WATERVIEW EAST PRELIMINARY PLAN

LOCATED IN A PORTION OF SECTION 9, T15S, R65W OF THE 6TH P.M.,
EL PASO COUNTY, STATE OF COLORADO

Computer File Information	
Creation Date: 2-27-17	Initials: CMD
Last Modification Date: 4-3-17	Initials: BG
Full Path & Drawing File Name: V:\1817\active\181710214\CAD\Plansheets Title Sheet	
Acad Ver. 2014	Scale: see plan Units: Feet

WATERVIEW EAST PRELIMINARY PLAN INDEX MAP		
Designer: BG	Structure Numbers	Sheet Number 2 of 9
Detailer: PF		
Sheet Subset:

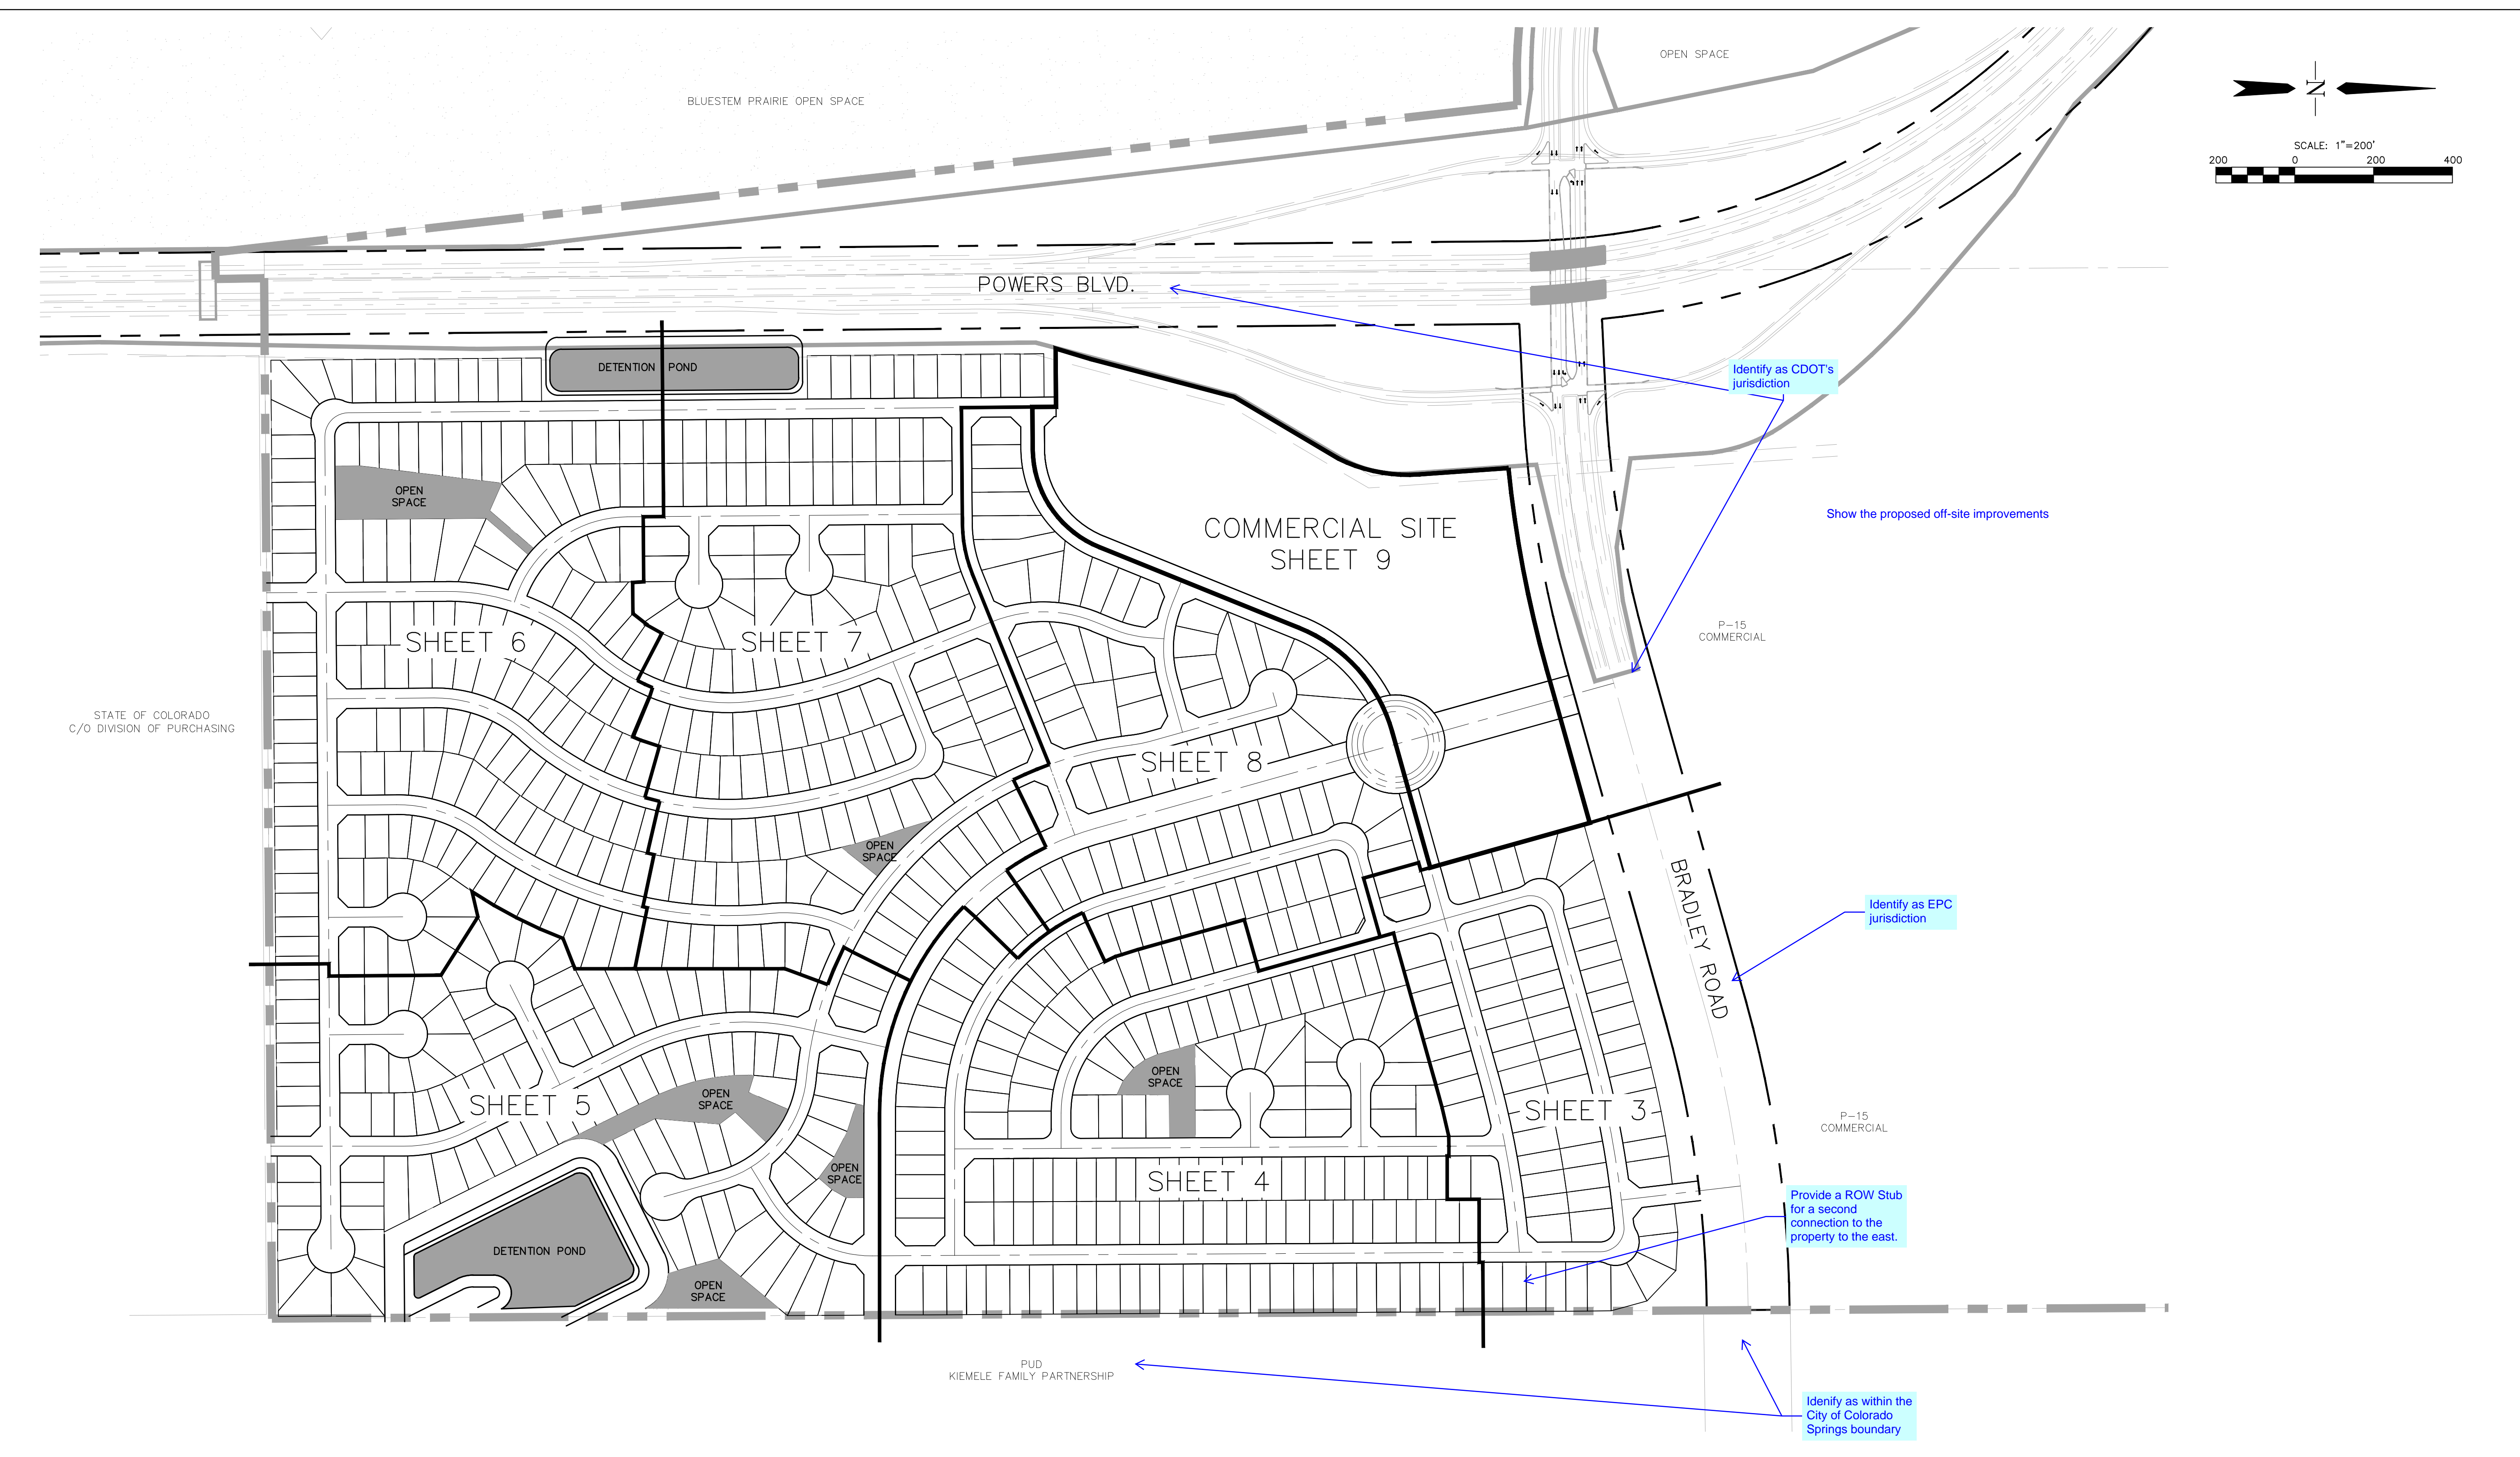
Provide a ROW Stub for a second connection to the property to the east.

Identify as EPC jurisdiction

Identify as within the City of Colorado Springs boundary

Identify as CDOT's jurisdiction

Show the proposed off-site improvements

WATERVIEW EAST PRELIMINARY PLAN		Project No./Code
Designer: CMD/BG	Structure Numbers	181710214
Detailer: PF/BG		Sheet Number 3 of 9

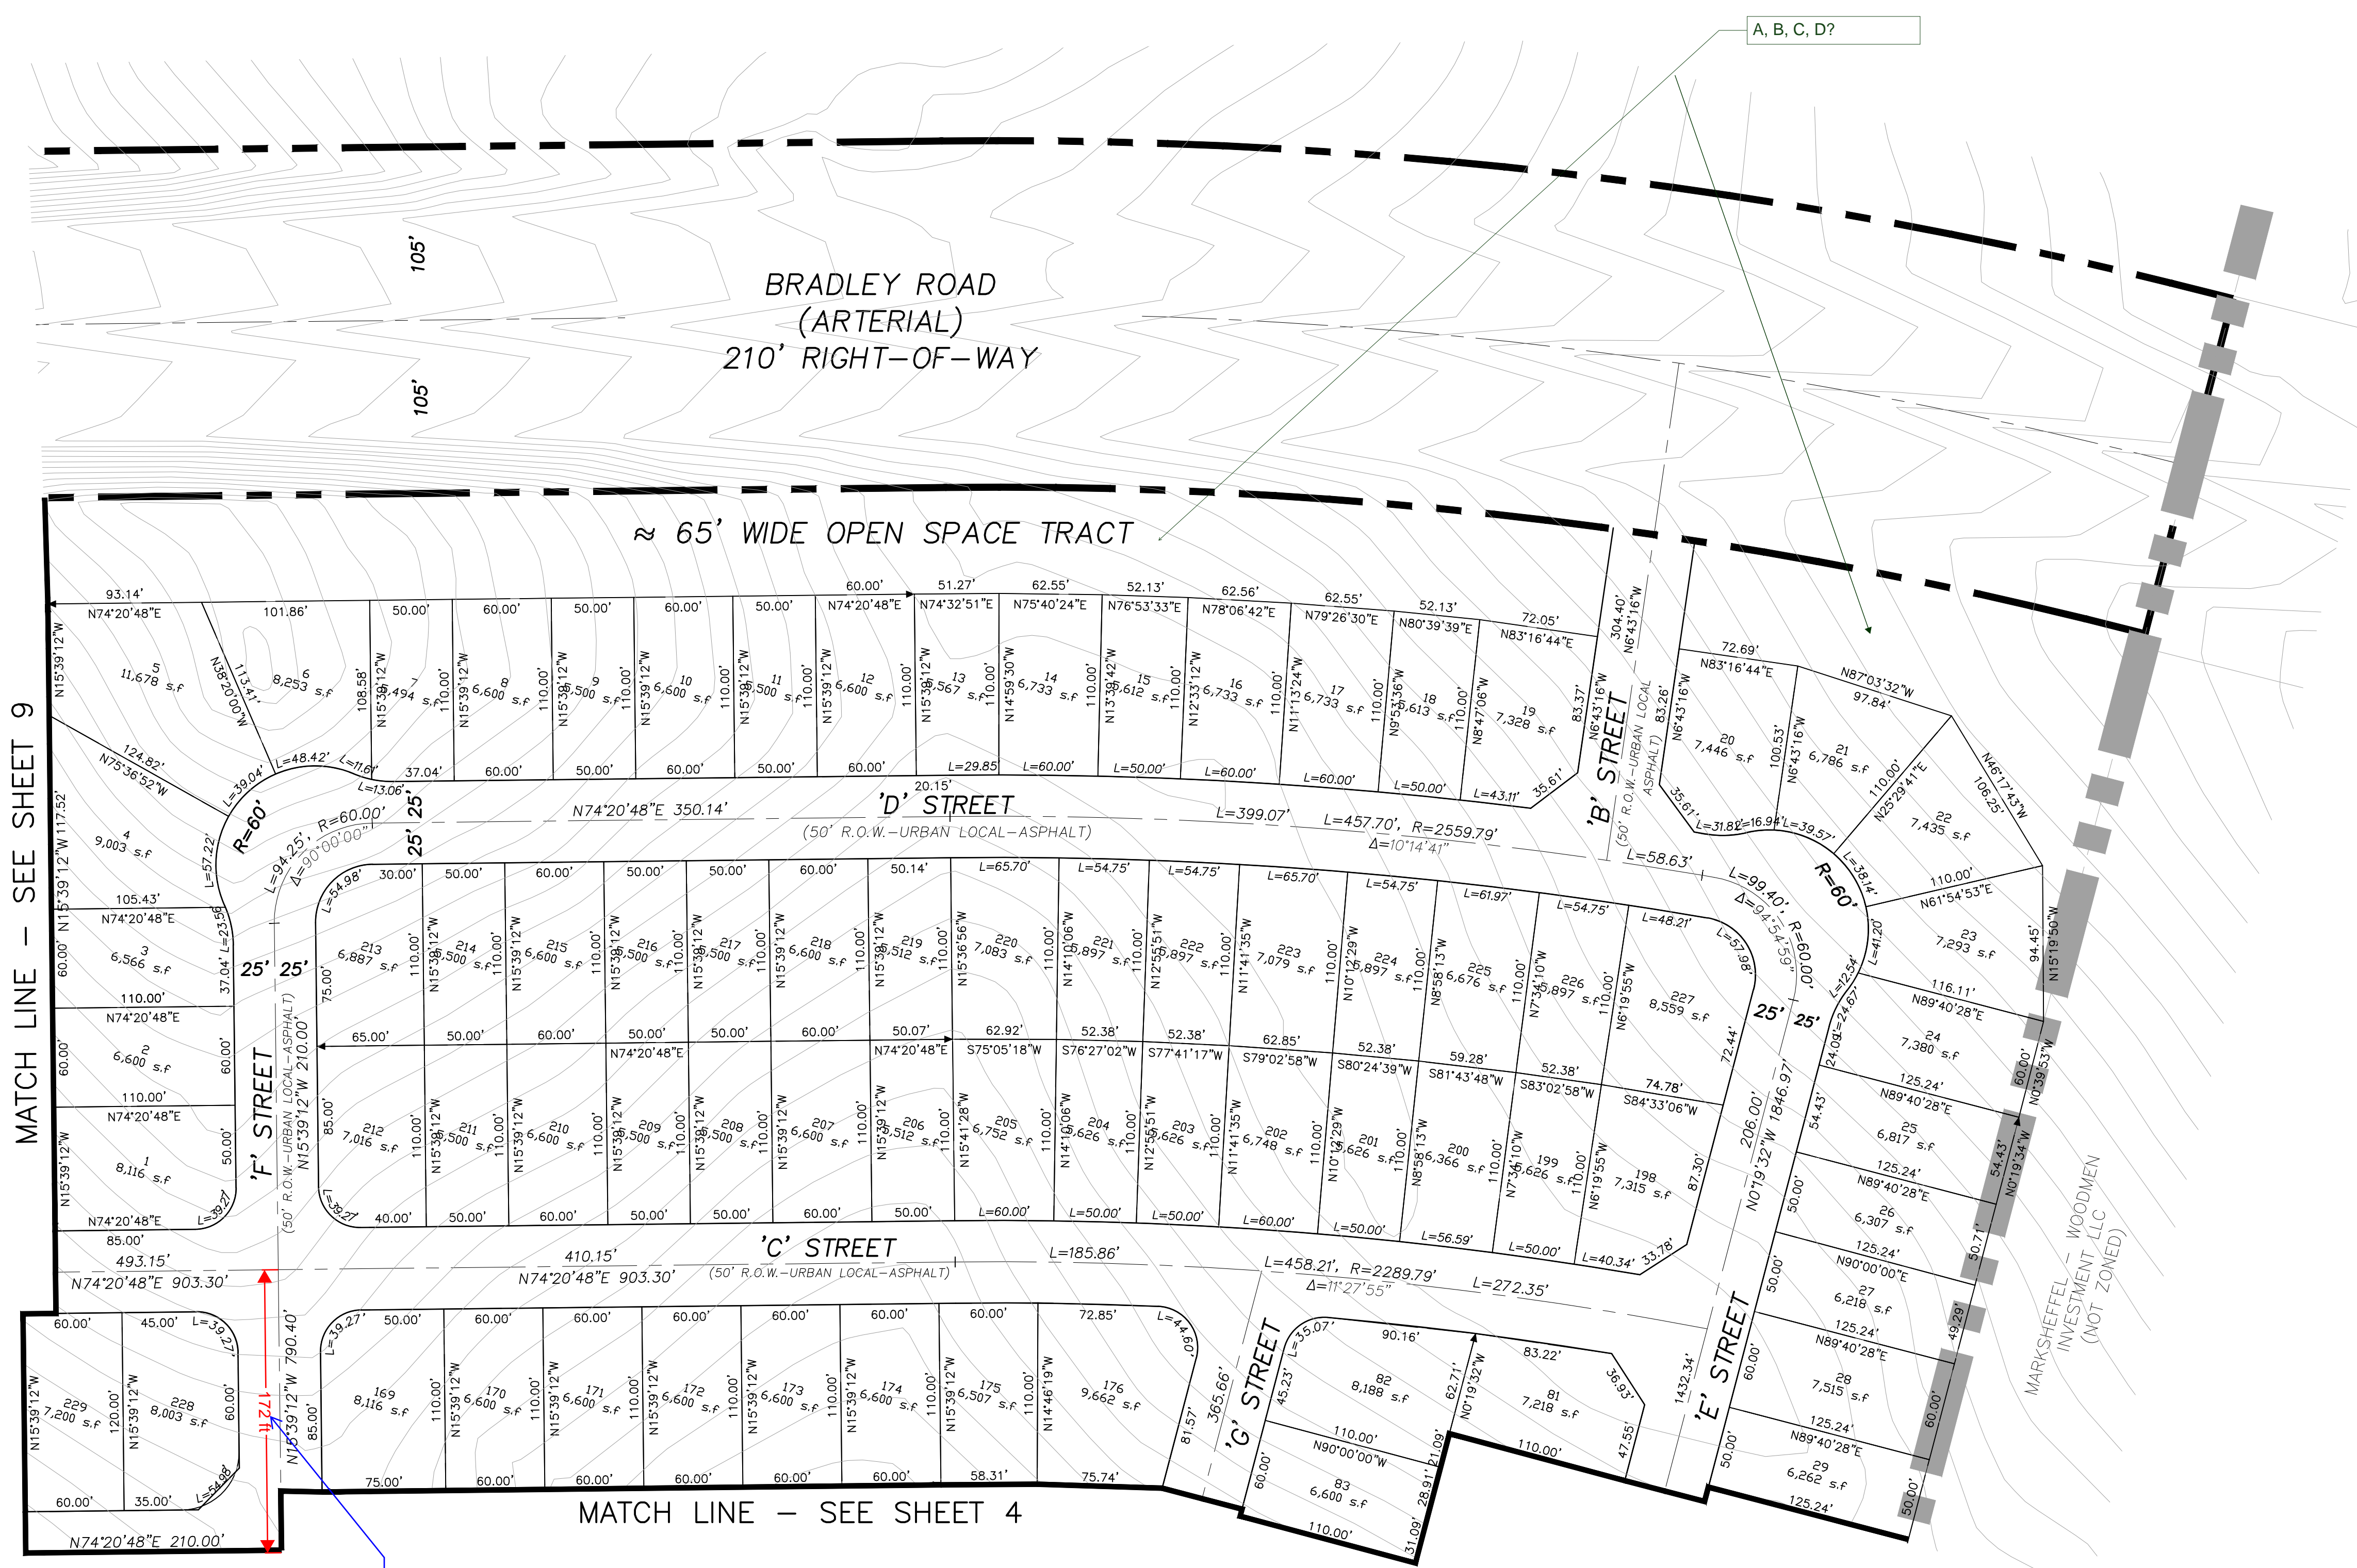
Add a key map on sheet 3 to 9

Show the roadway geometry (on and off site)

Does not appear to meet intersection spacing criteria

Project No./Code	181710214
Sheet Number	4 of 9

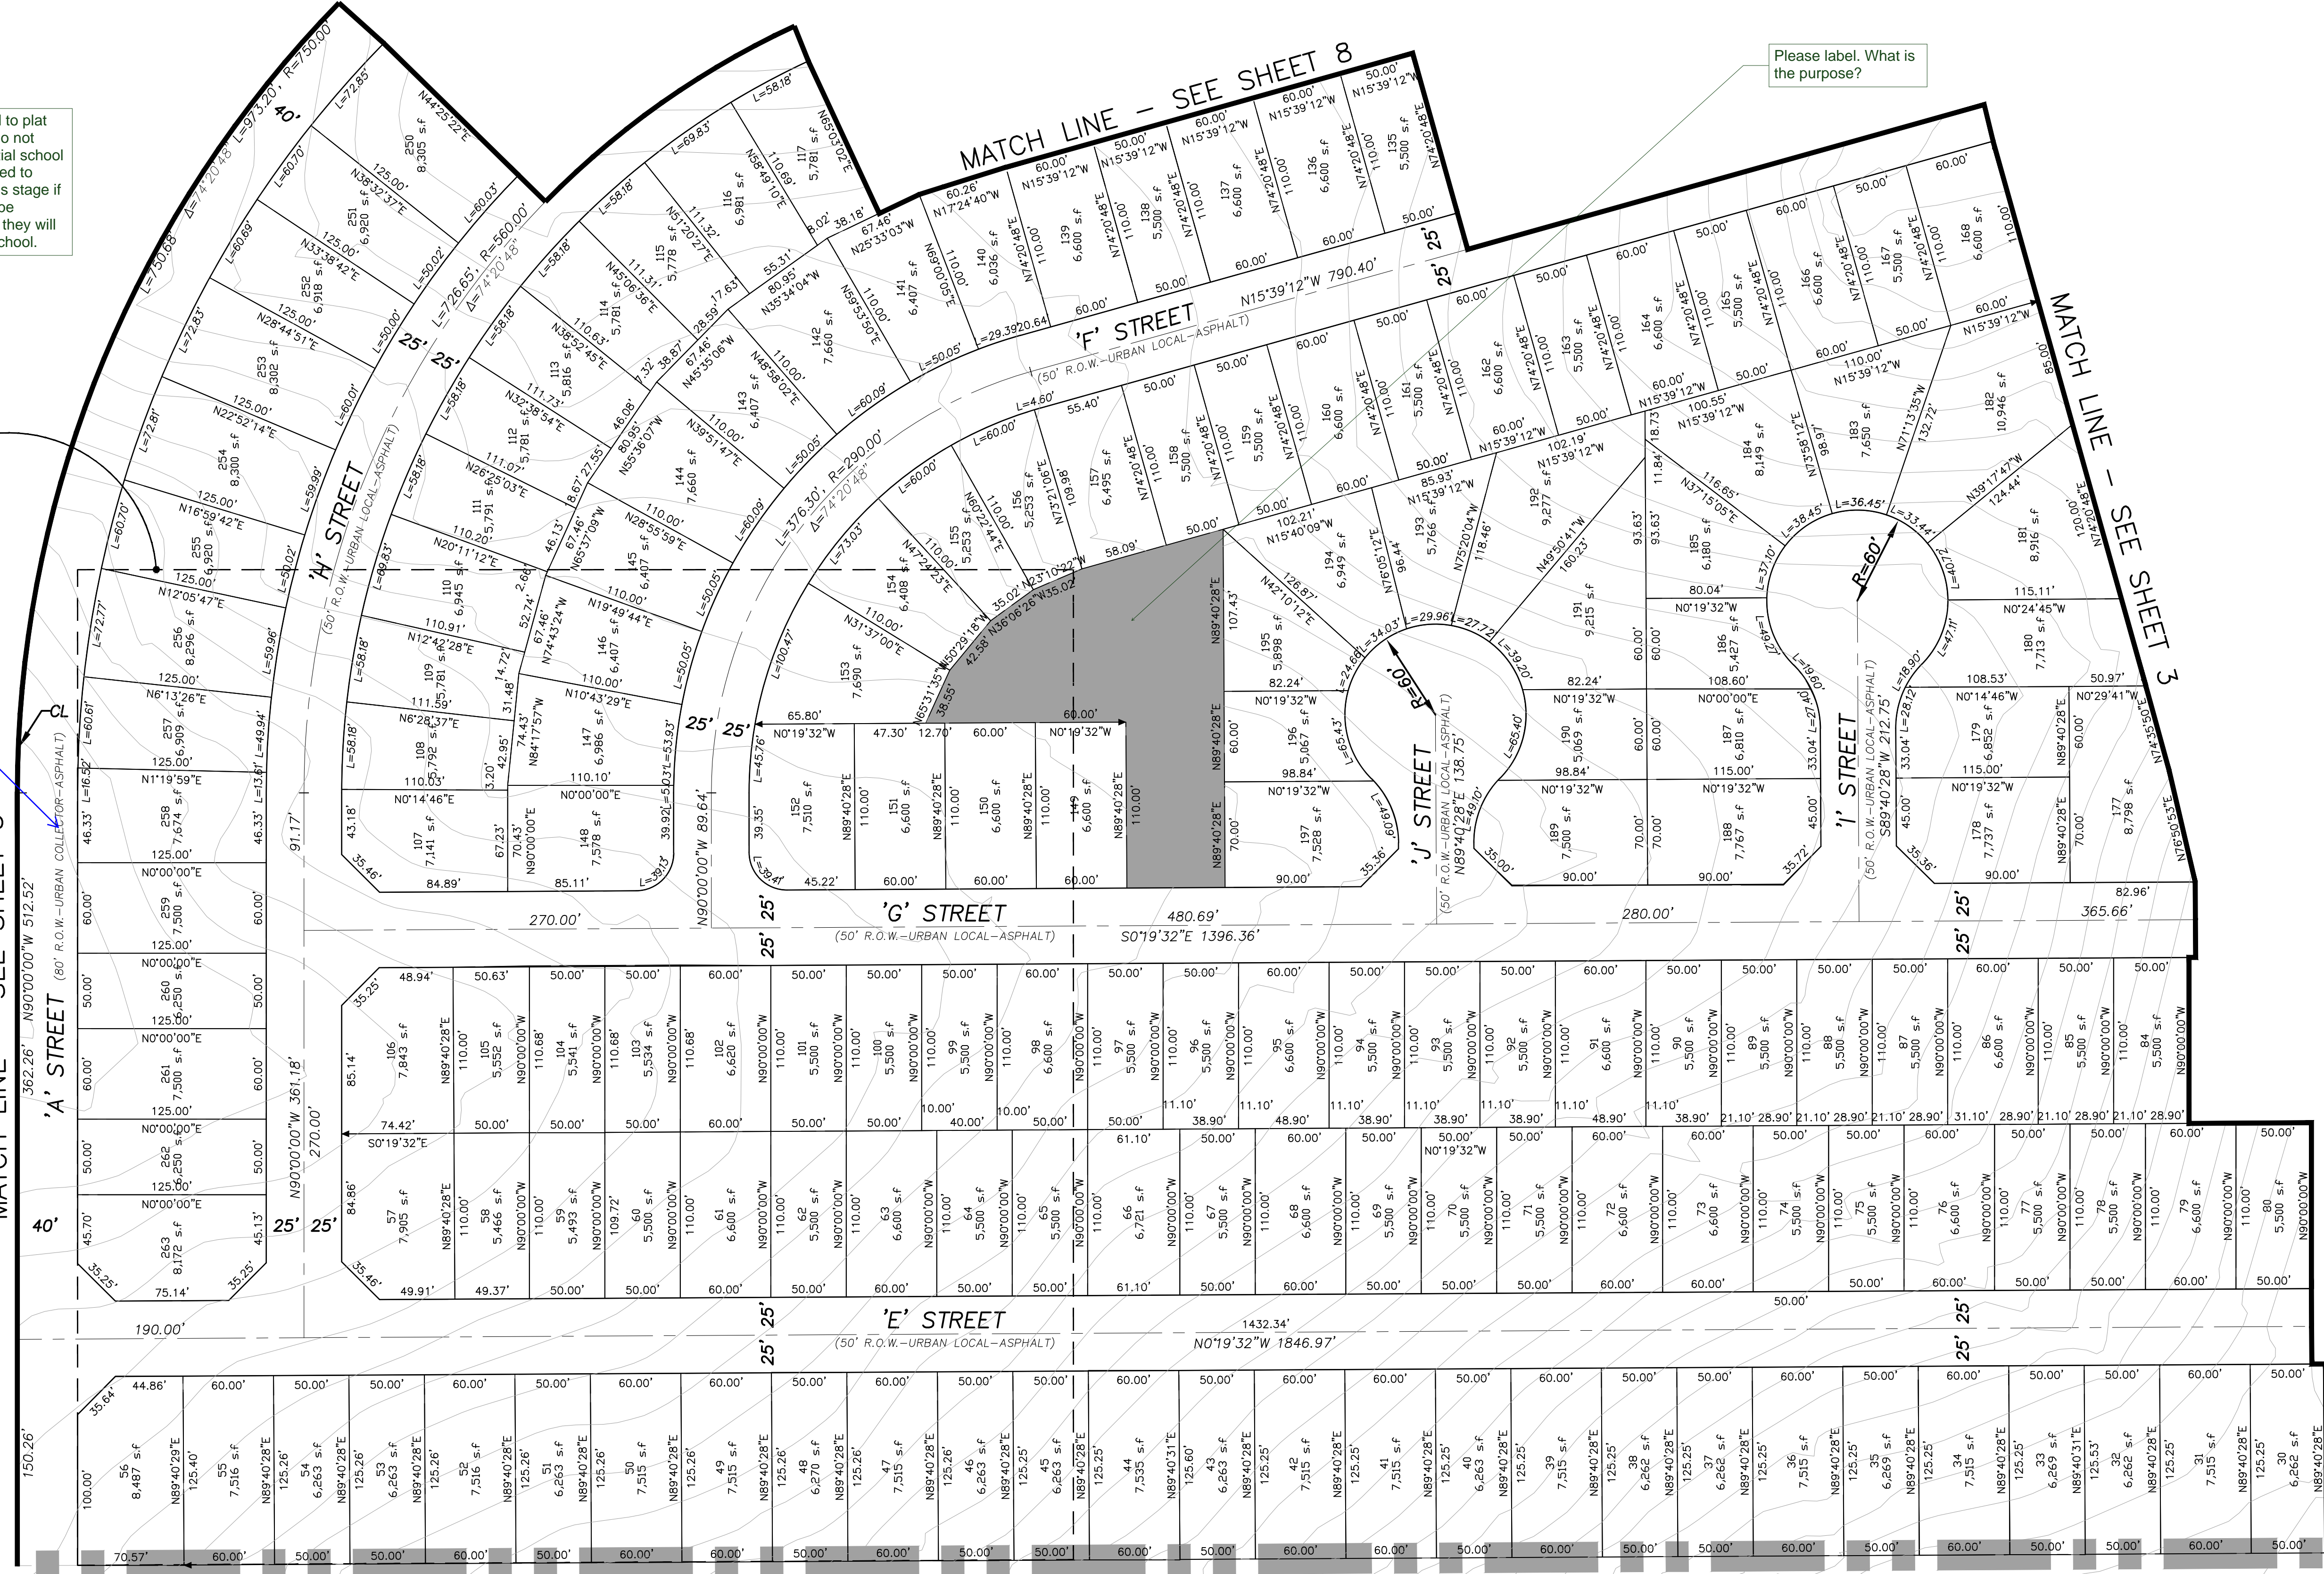
If you intend to plat these lots, do not show potential school site. You need to decide at this stage if the lots will be platted, or if they will become a school.

Revise label to "Urban Non-Residential Collector"

Please label. What is the purpose?
